High School in Jerrabomberra

Response to Submissions and SDRP

30.03.2022

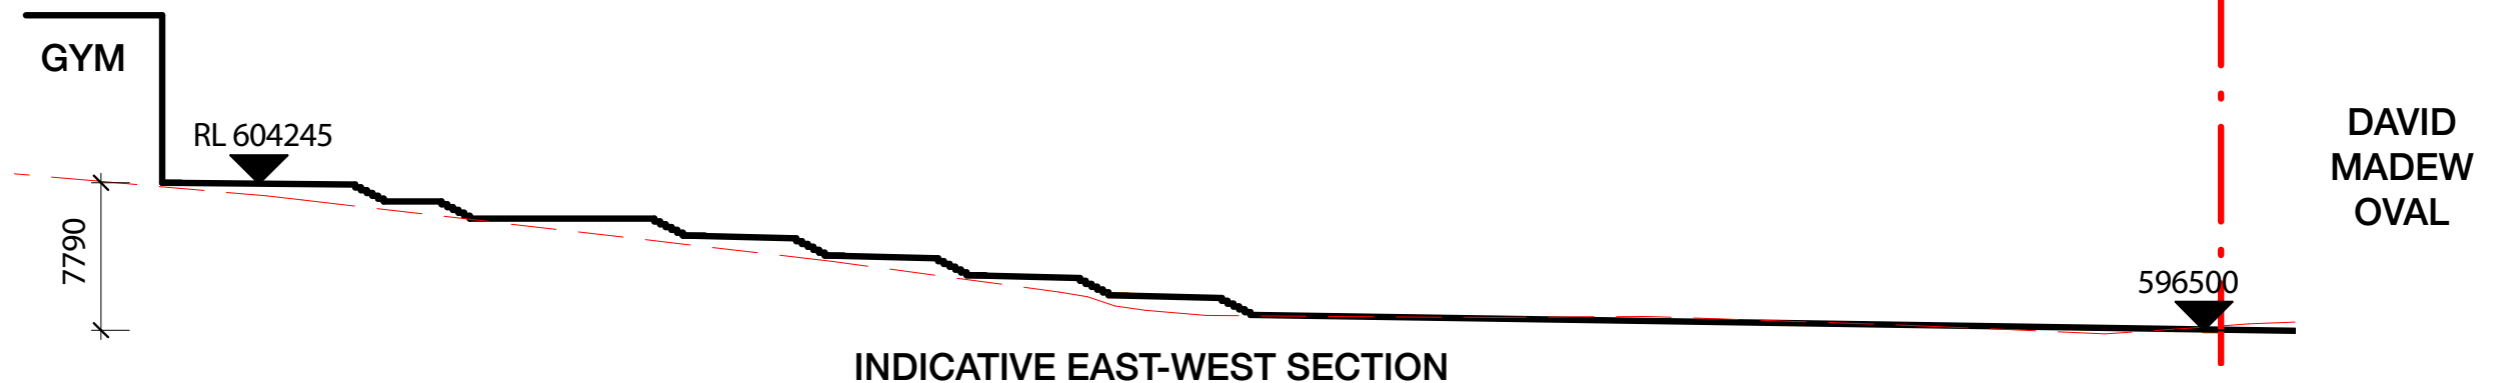
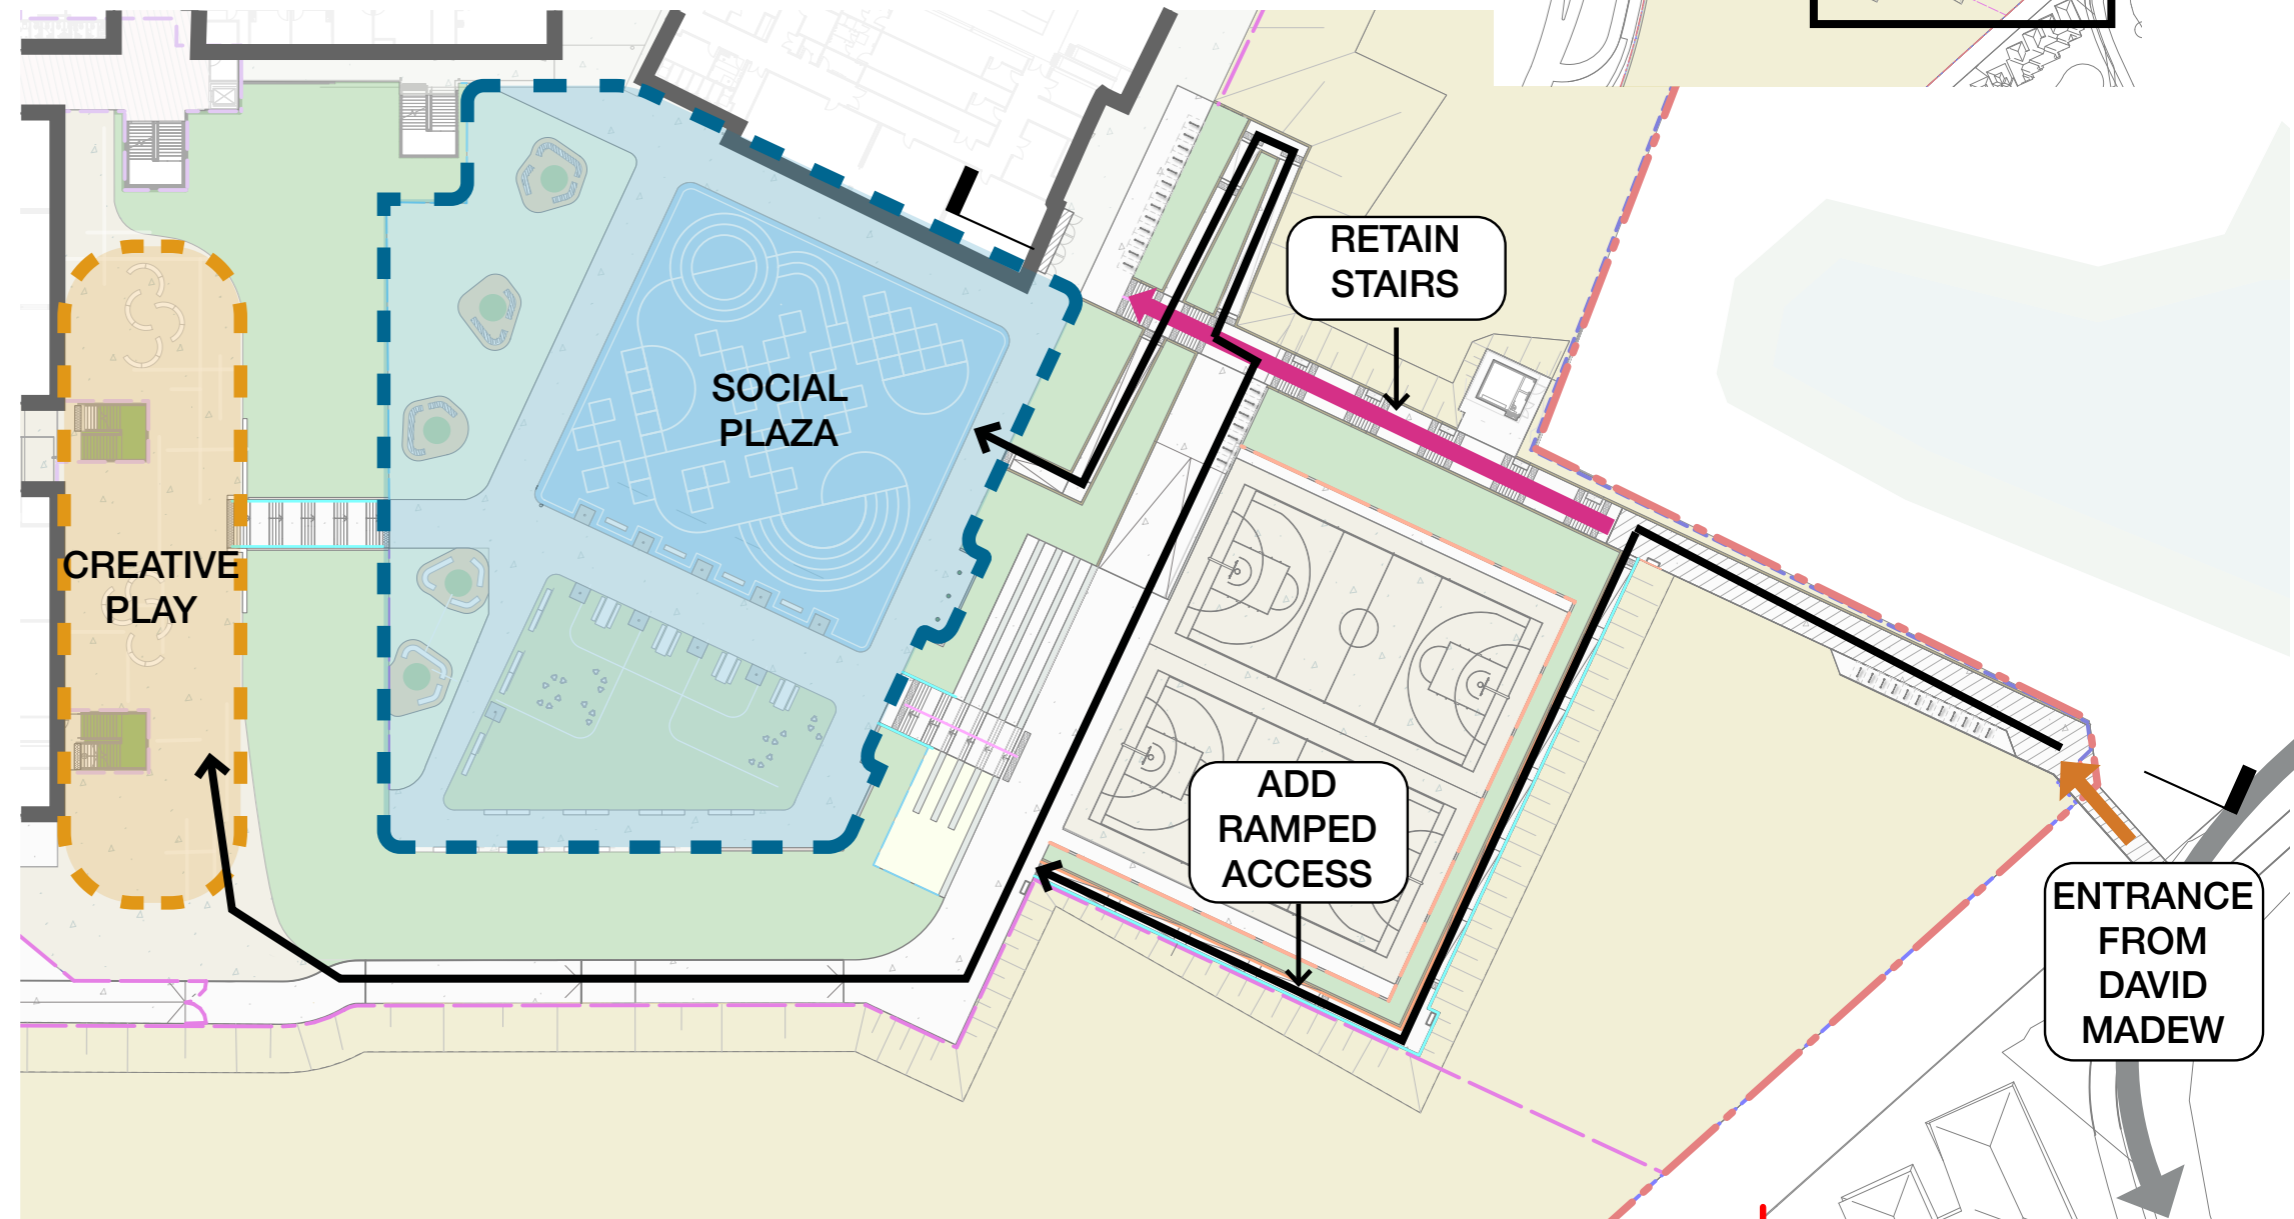
Recommendation 7c – the response does not include any options testing, and the recommendation to explore how the connection between the David Madew Oval and the school is connected and inclusive has not been adequately addressed. Options to provide an inclusive and equitable connection between the Oval and the school must be explored.

- OPTION 2:
 - Retain Stair access for abled-bodied users
 - Provide an accessible ramp system for use by all
 - This option maximises choice

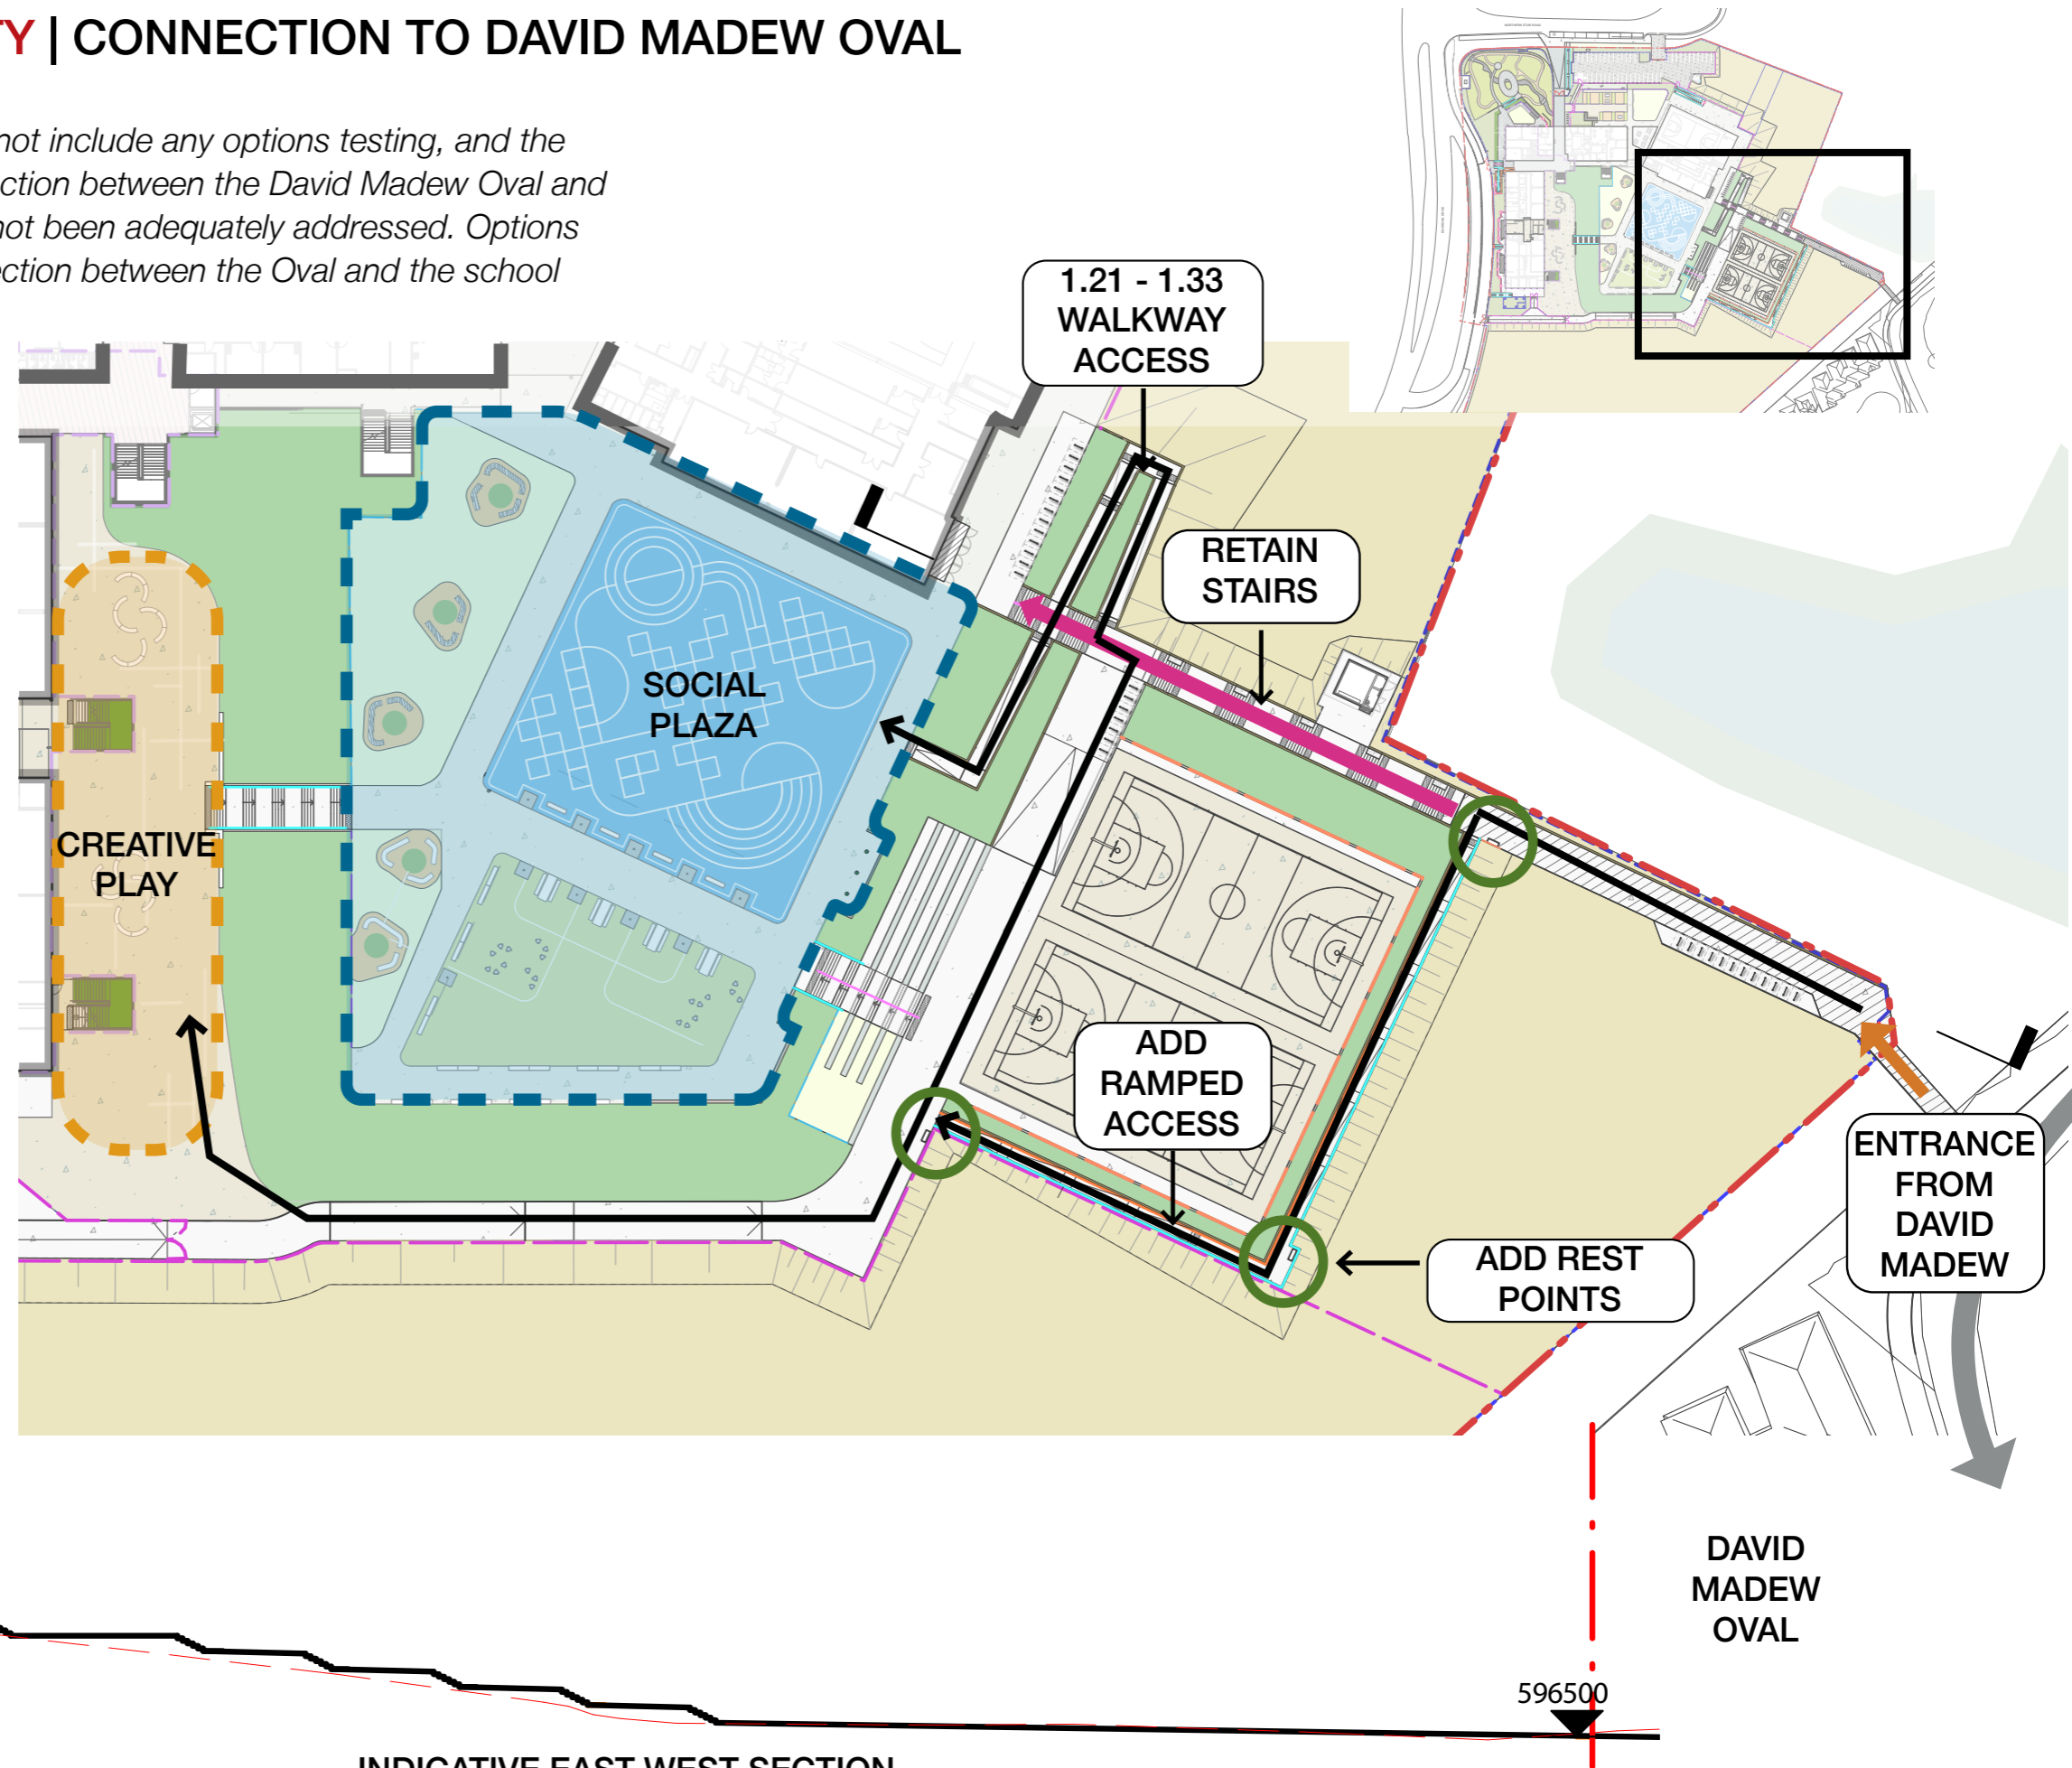
Recommendation 7c – the response does not include any options testing, and the recommendation to explore how the connection between the David Madew Oval and the school is connected and inclusive has not been adequately addressed. Options to provide an inclusive and equitable connection between the Oval and the school must be explored.

- OPTION 3 (PREFERRED):
 - Retain stairs
 - Provide accessible ramp around courts
 - Add rest stops to the ramp system at convenient intervals
 - This option incorporates accessibility and equity for all users, and maximises choice
- OTHER OPTIONS REVIEWED
 - Pedestrian ramp adjacent the stairs would be too steep
 - A lift option was also investigated, but found to be impractical given the distance to the plaza
